# Access Compliance Report

## Public Rights-of-Way

Intersection ID: 42459	Main Street: KINGSLEY_VIEW_DR	Cross Street: KING_LOUIS_CT	Location: SE
ADA ID: A8457FD71431	Ramp Type: PerpDiag	Initial Pass/Fail: Fail	Overall Compliance: No
Severity Score: 22.5			
Codes/Mitigation Info/Possible Solution		Field Measurements/Component Compliance

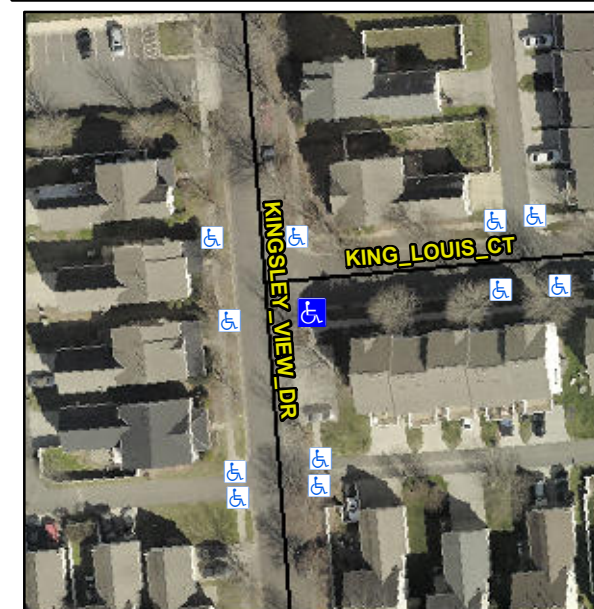
**Remove & Replace Curb Ramp With Two New Directional Ramps or Equivalent.**

**R304.5.1, R304.2.2**

Compliance	Description	Data	Compliance	Description	Data
N/A	Ramp Length (in)	74.0	No	Ramp Slope (%)	9.0
No	Ramp Width (in)	38.0	Yes	Ramp XSlope (%)	2.1
N/A	Flare Type LT	N/A	N/A	Flare Type RT	N/A
N/A	Flare Slope LT (%)	N/A	N/A	Flare Slope RT (%)	N/A
N/A	Flare Traversable LT?	N/A	N/A	Flare Traversable RT?	N/A
N/A	Landing Length (in)	N/A	N/A	DWS Provided?	N/A
N/A	Landing Width (in)	N/A	N/A	DWS Contrast?	N/A
N/A	Landing Slope (%)	N/A	N/A	DWS Length (in)	N/A
N/A	Landing X Slope (%)	N/A	N/A	DWS Full Width?	N/A
N/A	Landing Curb? (Y/N)	N/A	N/A	DWS Offset (in)	N/A
N/A	Shared Landing?	N/A			
N/A	Gutter Ponding?	N/A	N/A	Gutter Slope (%)	N/A
N/A	Gutter Lip Ht (in)	N/A	N/A	Gutter X Slope (%)	N/A
N/A	Painted X Walk1?	No	N/A	Painted X Walk2?	No
	X Walk 1 Direction	To N		X Walk 2 Direction	To W
N/A	X Walk 1 Width (in)	N/A	N/A	X Walk 2 Width (in)	N/A
	X Walk 1 Slope (%)	1.3		X Walk 2 Slope (%)	2.8
	X Walk 1 X Slope (%)	1.5		X Walk 2 X Slope (%)	2.0
